ITEM 6.1: **Specific Plan Amendment, Conditional Use Permit, and Design Review Permit – 1513 Eureka Road – NERSP PCL 8 – Sprinter Roseville – File #PL23-0124**

REQUEST

Figure 3: Preliminary Site Plan

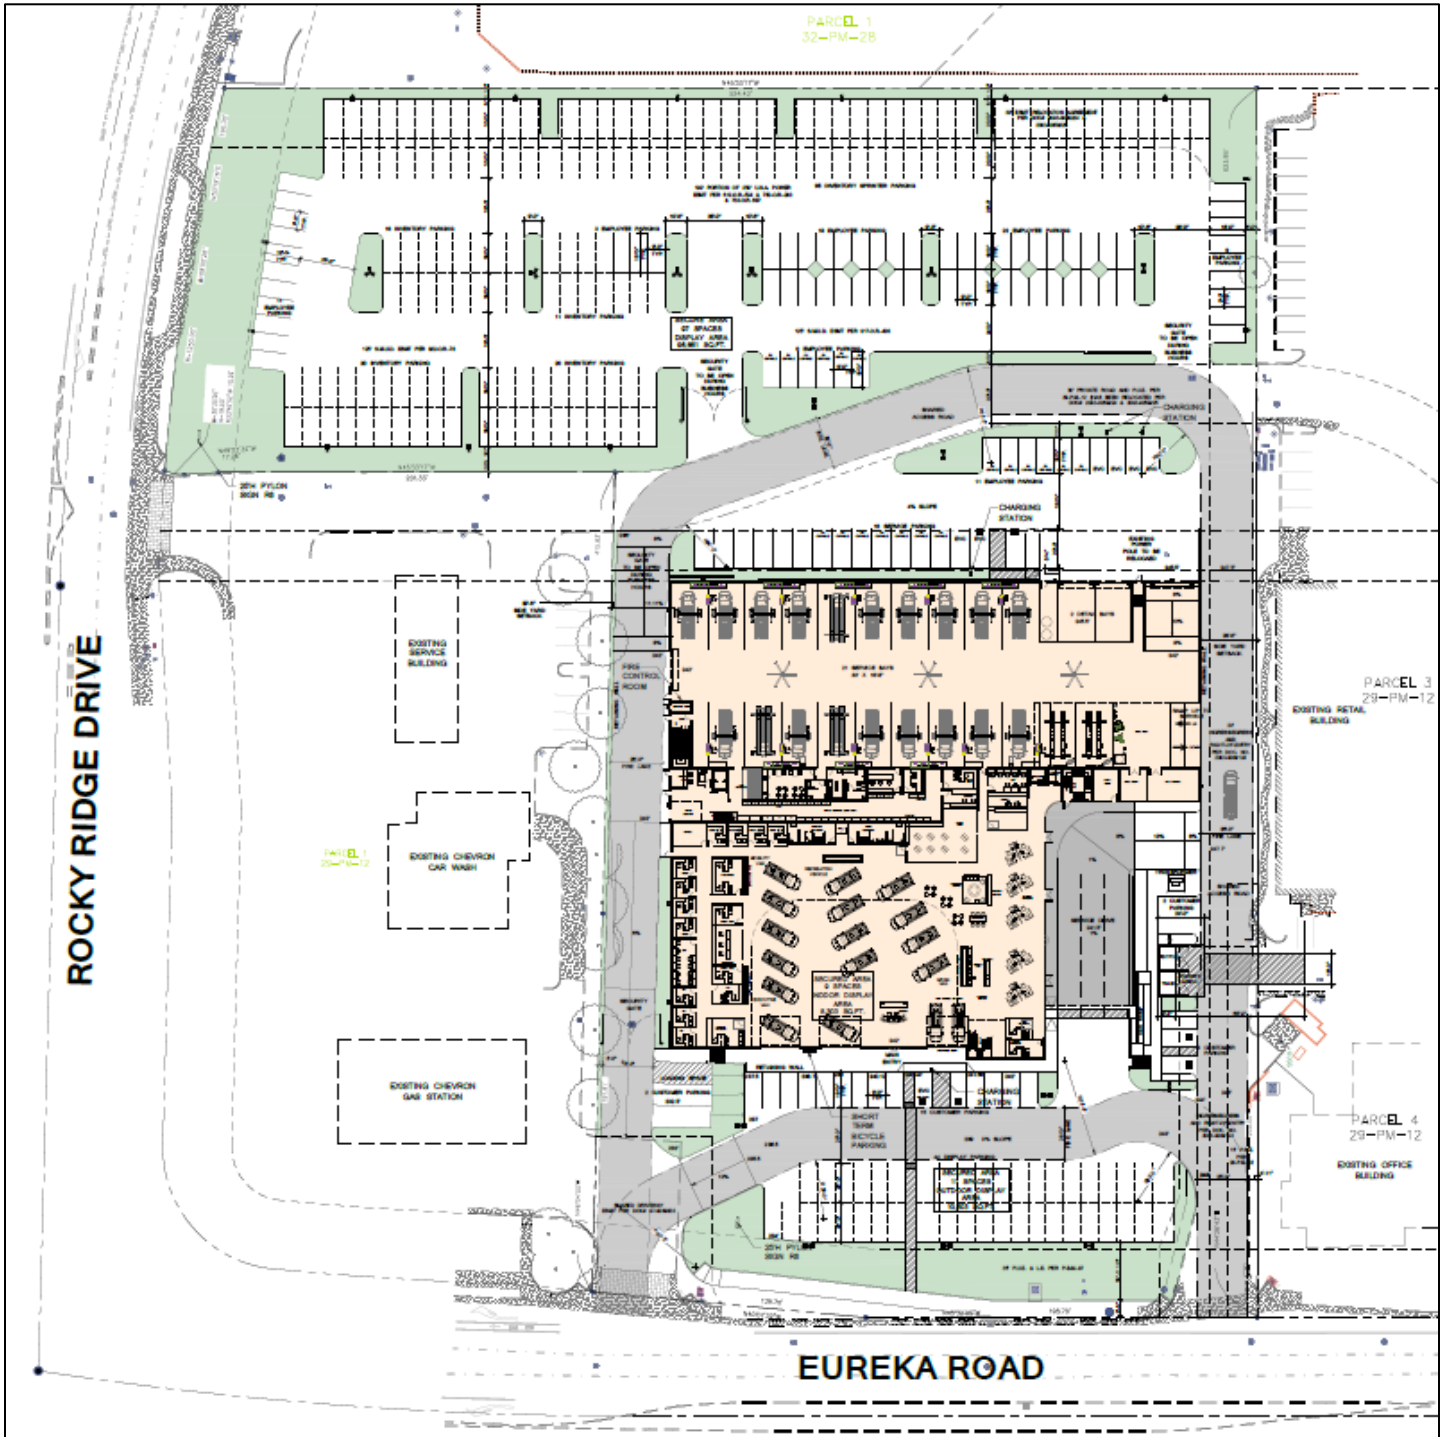
The portion of the project site located at 1411 Eureka Road is mostly encumbered with utility easements, and no permanent structures are permitted within these easements. As a result, the project proposes to develop this parcel with surface parking stalls for employees, patrons and vehicle inventory. The building will be located at 1513 Eureka Road and must maintain at least 15 feet of clearance from the nearest power line. This will require an existing power pole that is located to the northeast corner of the proposed building to be relocated by Roseville Electric at the developer's expense. The building will have frontage on Eureka Road and will be located approximately 130 feet from Eureka Road and approximately 275 feet from Rocky Ridge Drive, behind the existing gas station site. The proposed setbacks provide a sufficient buffer from the street and adequate space for landscaping, providing an appropriate streetscape presence consistent with the CDG and NERSP. In addition, the Parcel 8 Design Guidelines indicate a maximum lot coverage of 35 percent for a multiple-story building. The footprint of the proposed building is approximately 59,000 square feet and the site is approximately 247,000 square feet, which is a lot coverage of 24 percent.

The site plan identifies proposed freestanding signs at the driveway entrances, however, these signs are not approved as part of the Design Review Permit (see Condition #61 of the DRP). The signs will require a separate sign permit and will be reviewed for consistency with the signage requirements of the NERSP Parcel 8 Design Guidelines and the City's Sign Ordinance.

The project includes three points of access to the adjacent roadways, and will utilize the existing driveway on Rocky Ridge Drive and the two existing driveways on Eureka Road. The driveways on Eureka Road have shared access with the adjacent properties. The western driveway on Eureka Road will be modified to accommodate a 140-foot right-turn curb flare. The Parcel 8 Design Guidelines require the internal vehicular circulation drives be designed to provide shared access and common driveways between buildings on Parcel 8, and the site plan (as shown in Figure 3 and Exhibit D) is consistent with that intent. The project was reviewed by the City Engineering and City Fire Department staff and was found to comply with refuse service standards and with emergency circulation requirements.

- 61. Signs shown on the elevations are not approved as part of the Design Review Permit. A Sign Permit is required for all project signs. (Planning)
- 62. Following the installation of the landscaping, all landscape material shall be maintained in a healthy and weed-free condition; dead plant material shall be replaced immediately. All trees shall be maintained and pruned in accordance with the accepted practices of the International Society of Arboriculture (ISA). (Planning)
